**ADMINISTRATIVE AMENDMENT**

CITY OF ALBUQUERQUE / FAMILY & COMMUNITY SERVICES  
 SINGING ARROW COMMUNITY CENTER

City Project No. **5441.95** Zone Map No. **L-22-Z** Sheet **AS101** of **85**

**PARTIAL DIMENSION SITE PLAN**  
 SCALE: 1" = 10'-0"

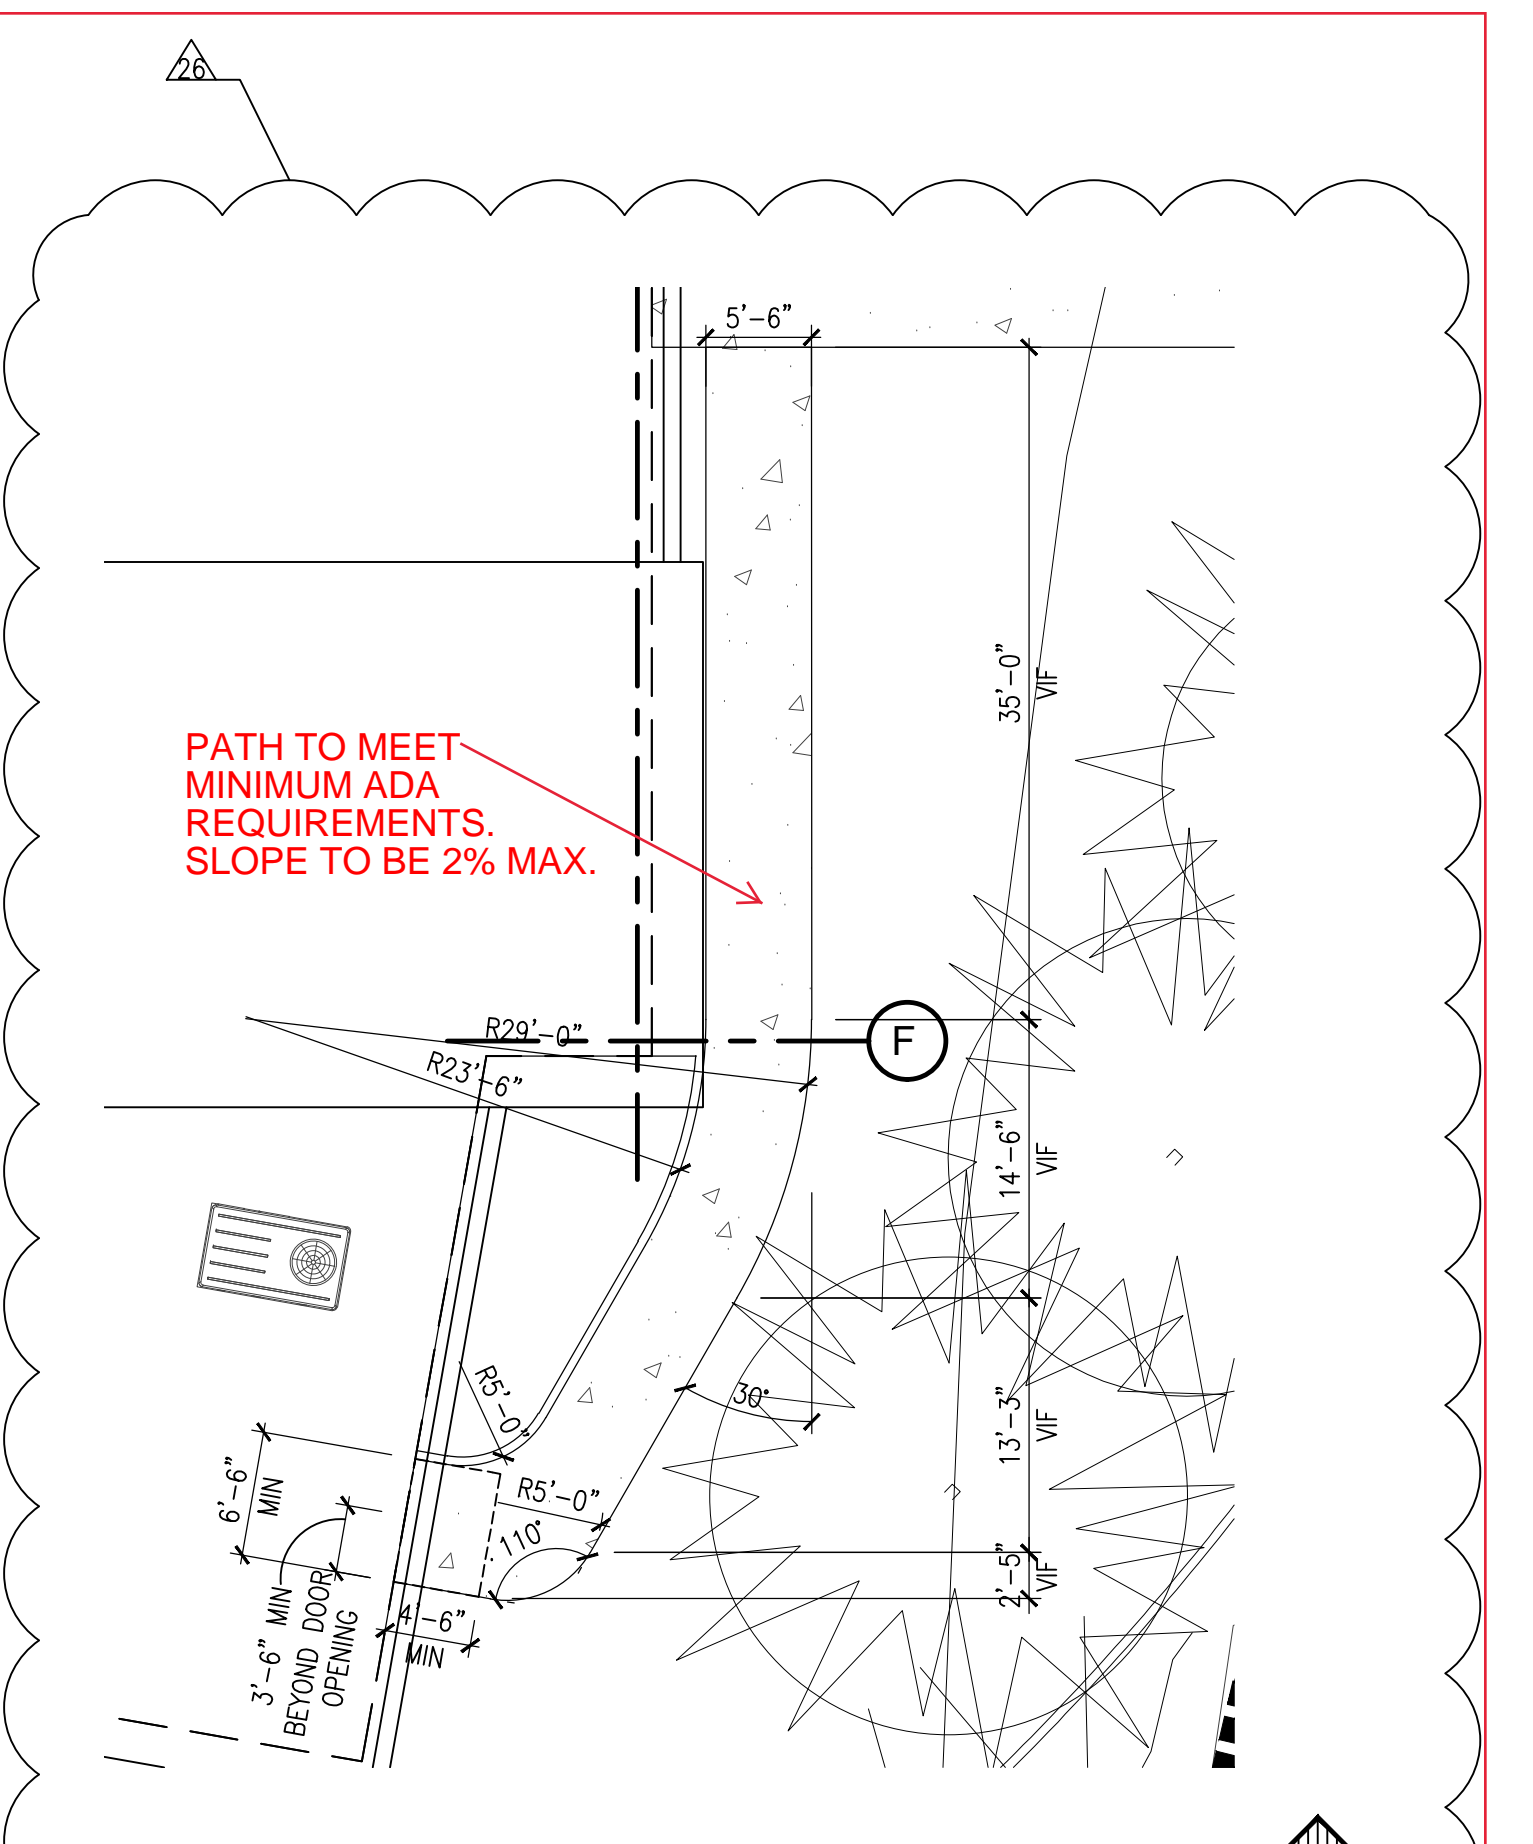
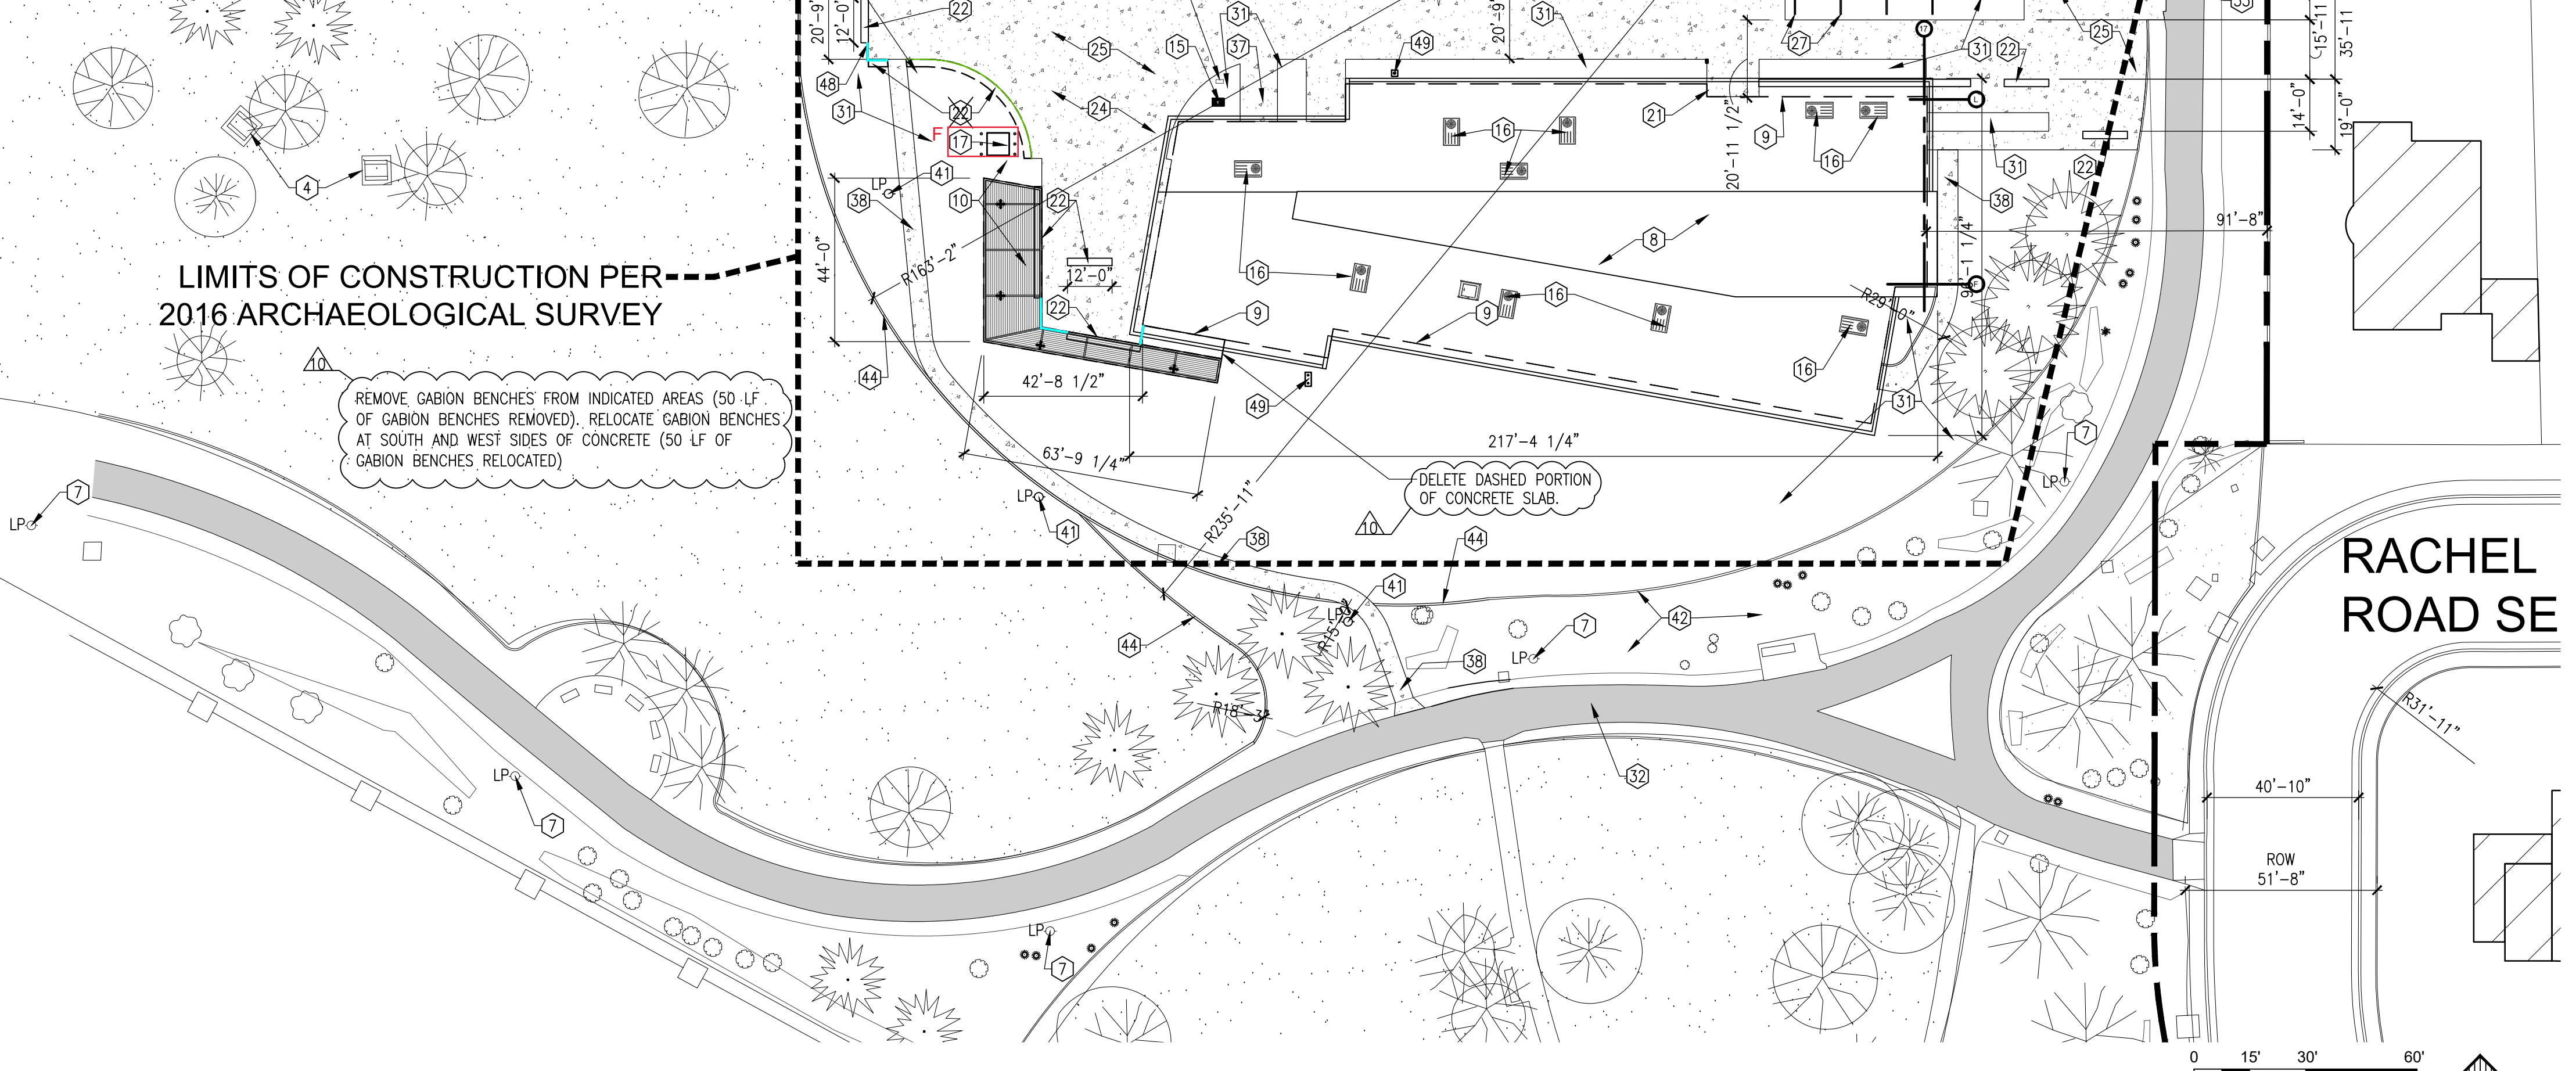
AT GREEN LINE, PROVIDE TURNDOWN EDGE ONLY PER DETAIL B5/AS501  
 AT BLUE LINES, PROVIDE TURNDOWN EDGE PLUS CURB PER DETAIL B5/AS502  
 AT ORANGE LINE, PROVIDE MONOLITHIC HEADER CURB PER DETAIL C5/AS502; GRADUALLY STEP DOWN TO NORMAL HEADER CURB HEIGHT.

REMOVE TWO EXISTING TREES TO COMPLETE GRADING

REMOVE GABION BENCHES FROM INDICATED AREAS (50 LF OF GABION BENCHES REMOVED). RELOCATE GABION BENCHES AT SOUTH AND WEST SIDES OF CONCRETE (50 LF OF GABION BENCHES RELOCATED).

DELETE DASHED PORTION OF CONCRETE SLAB

# PARTIAL SITE PLAN

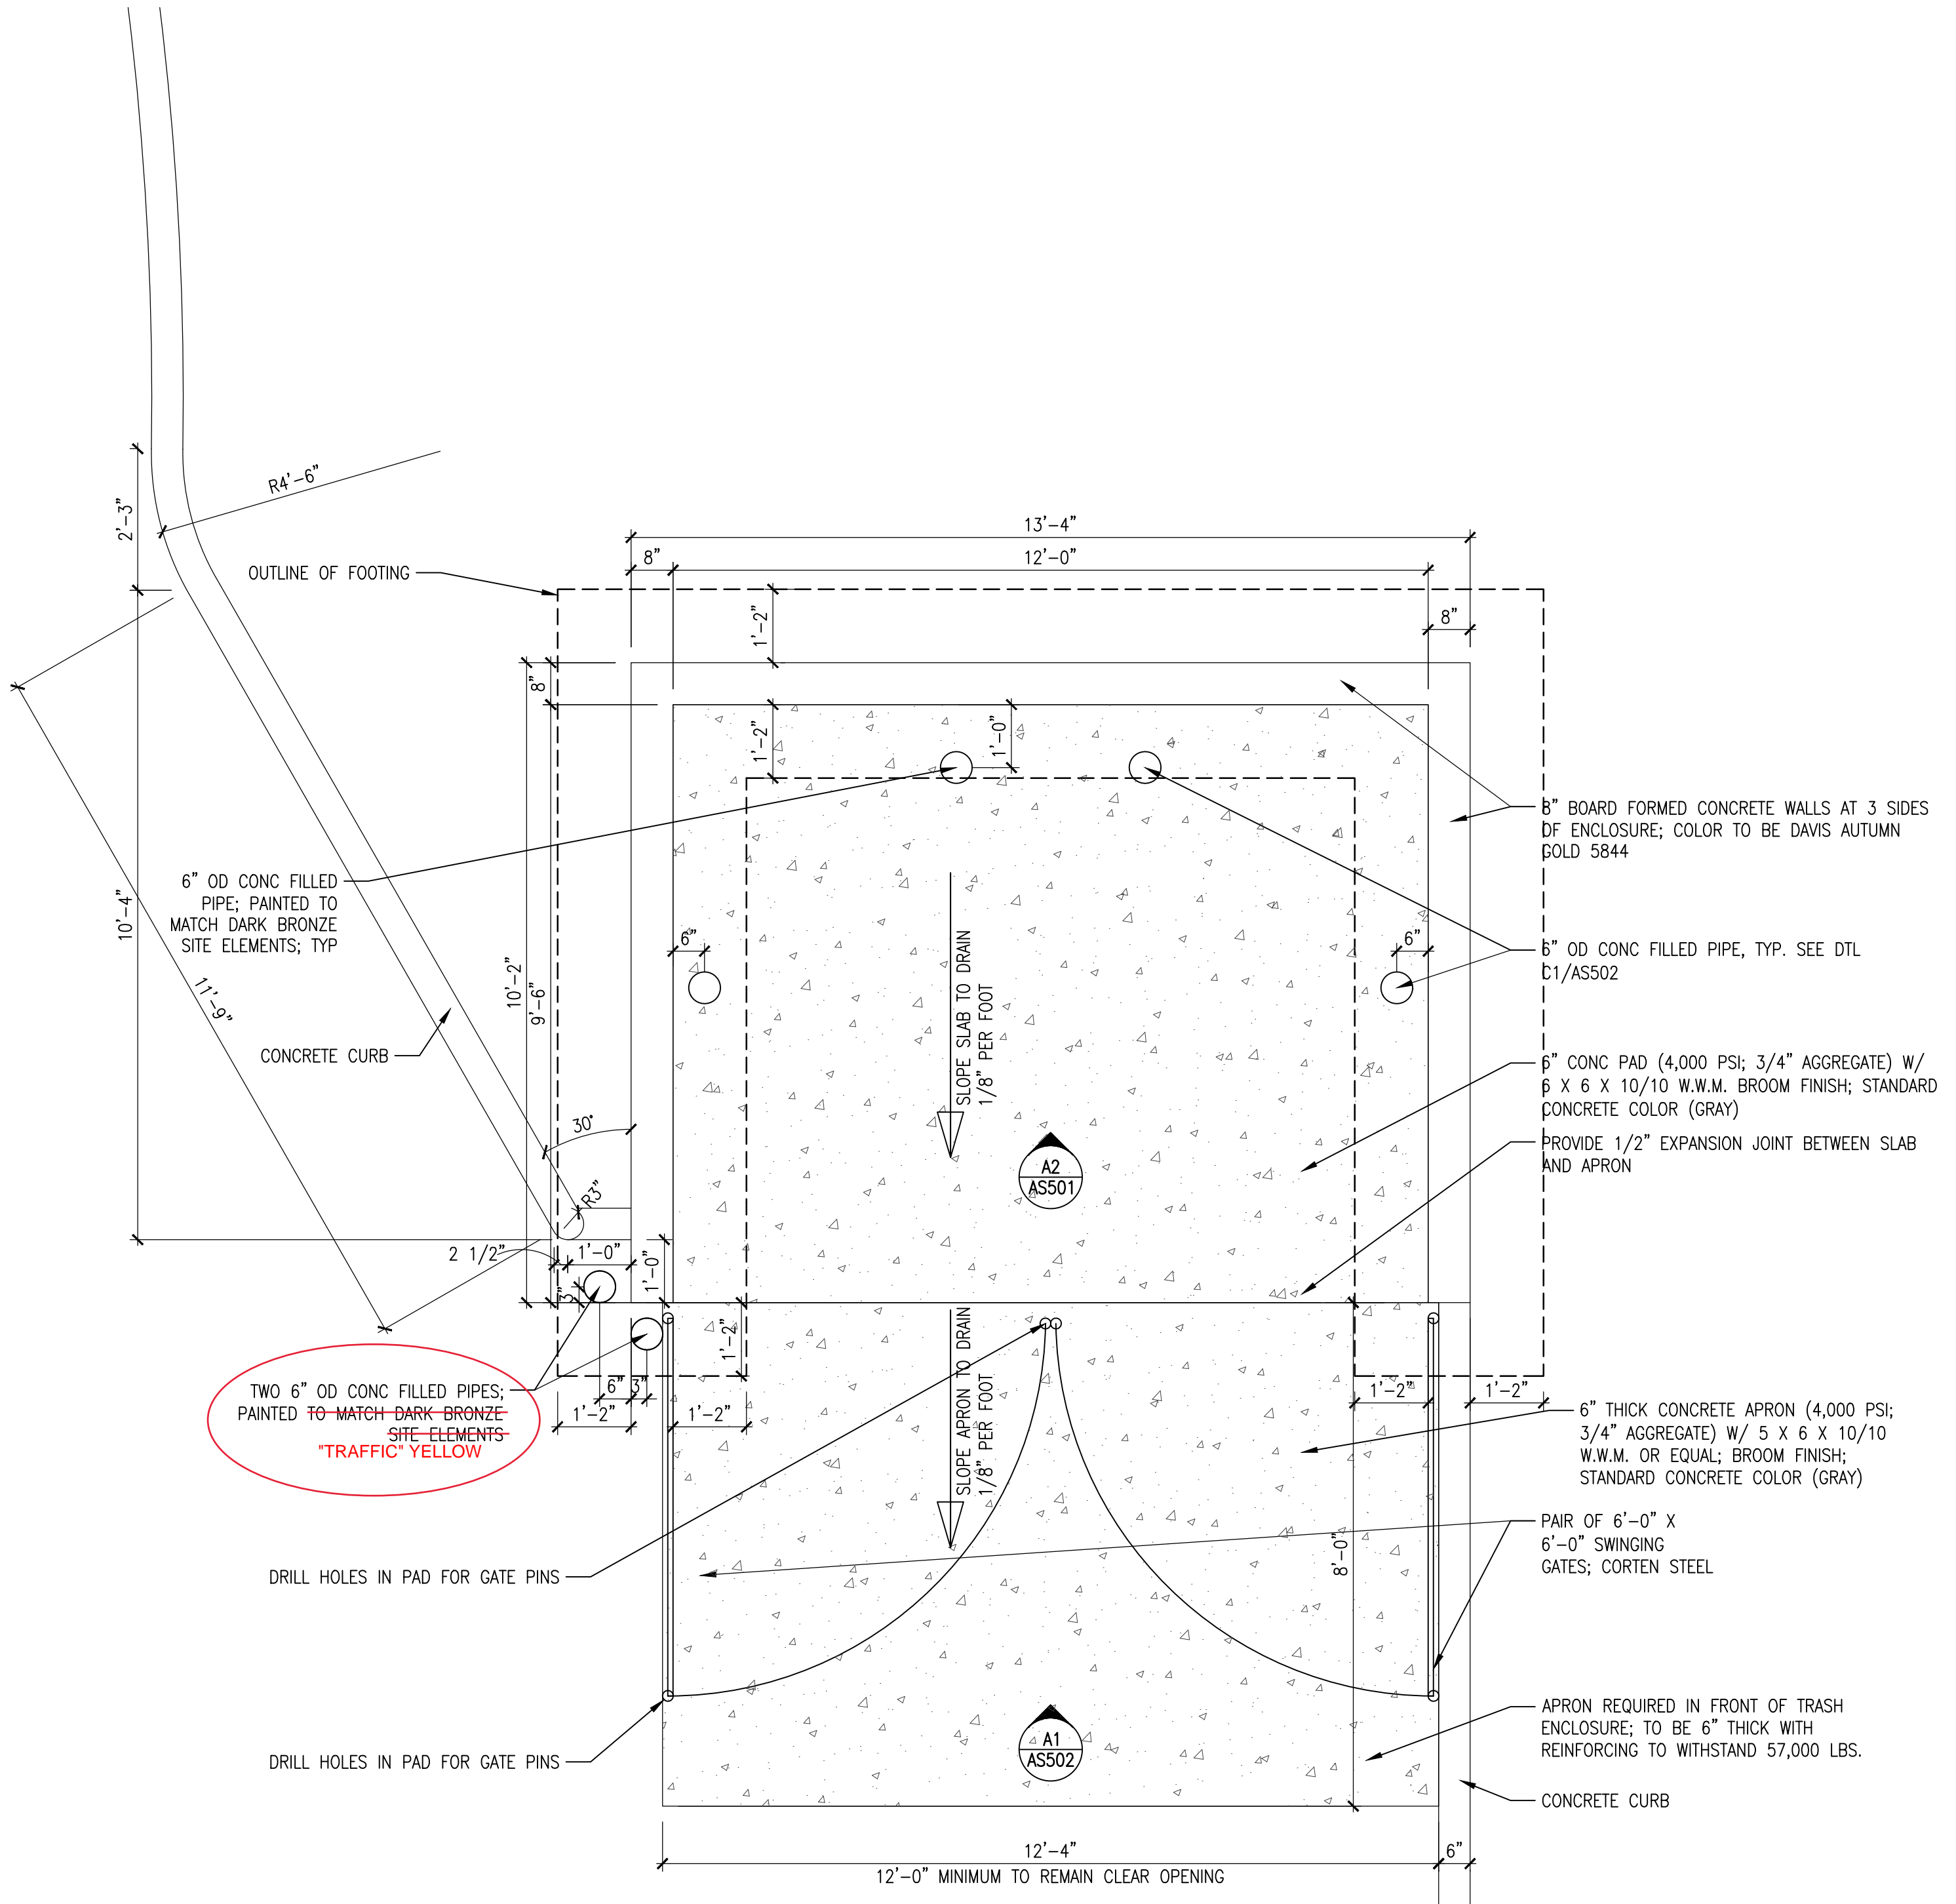
B2 REFUSE ENCLOSURE ENLARGED PLAN  
AS501 REVISED

**B5 TYP CONC. TURNDOWN EDGE WITH CURB DTL.**  
 SCALE: 1"=1'-0"

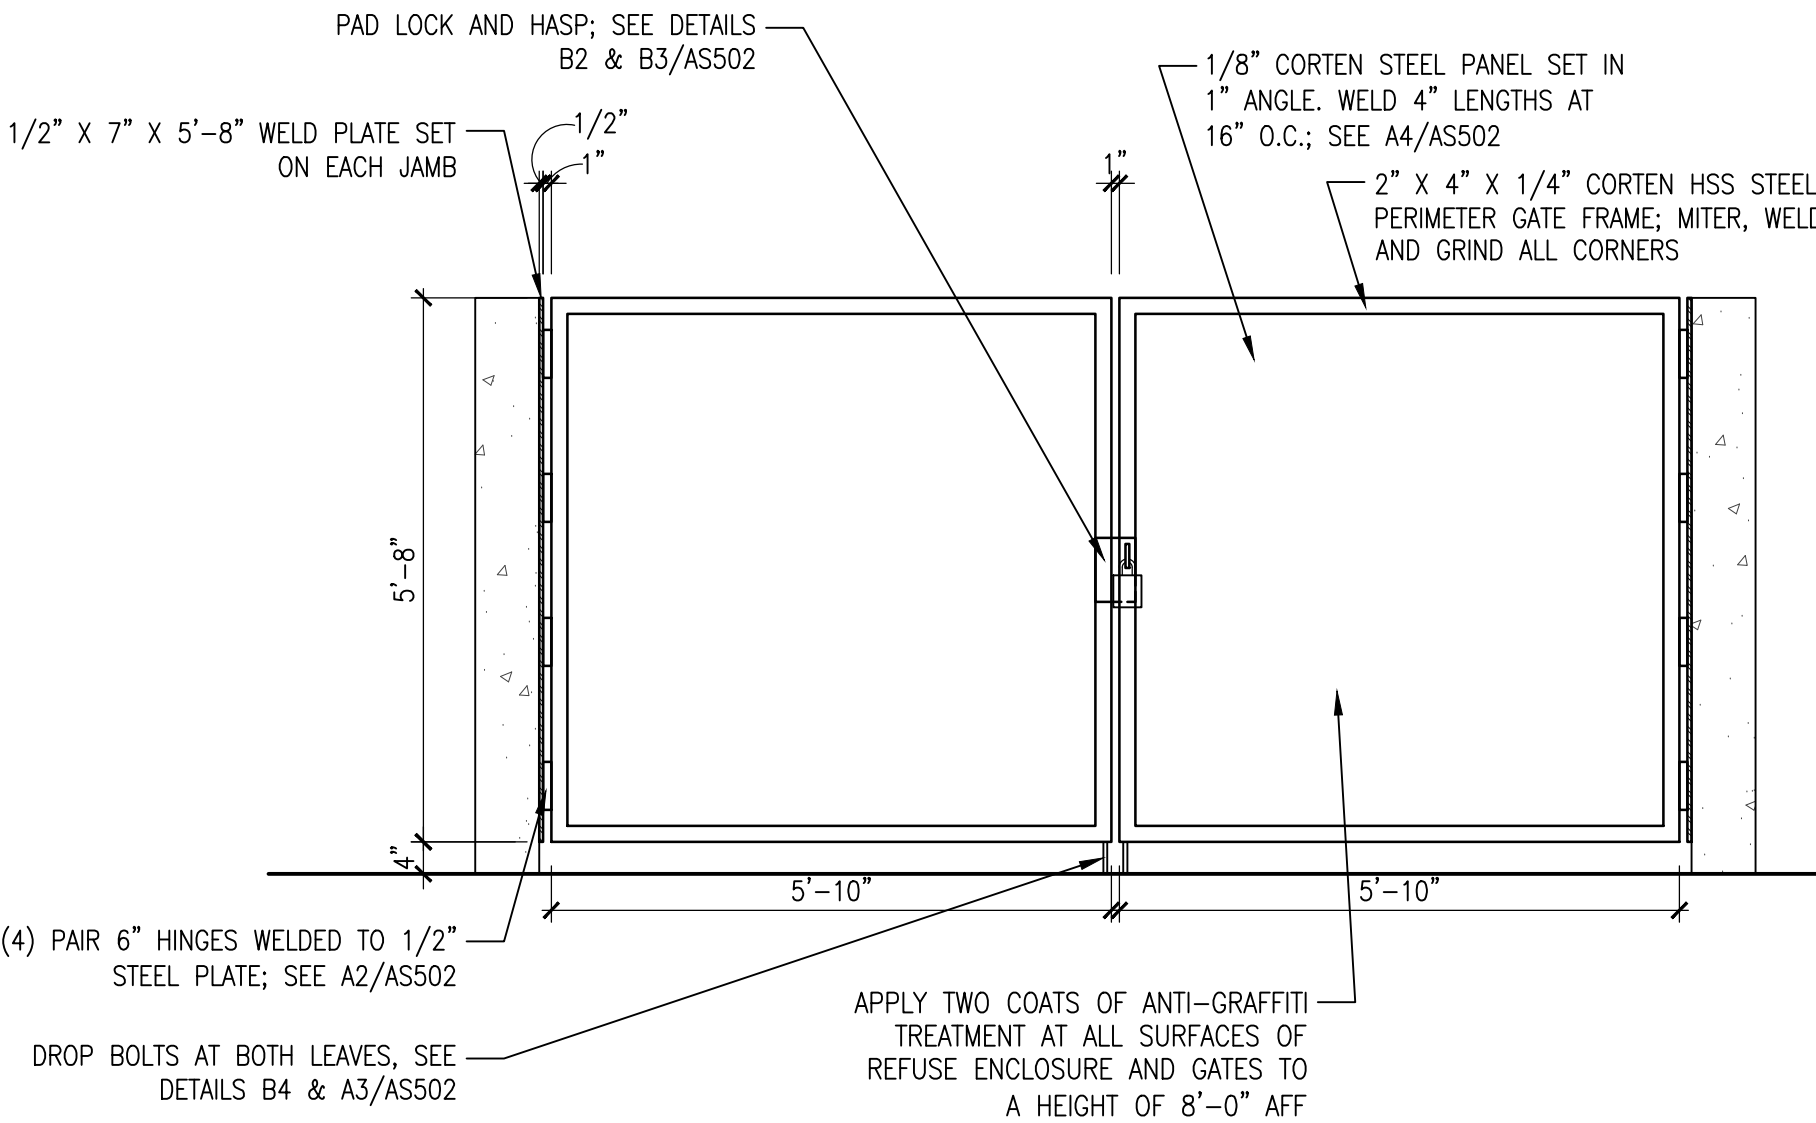
REMOVE DETAIL B5/AS502 IN ITS ENTIRETY  
 ADD NEW DETAILS B5/AS502 AND C5/AS502
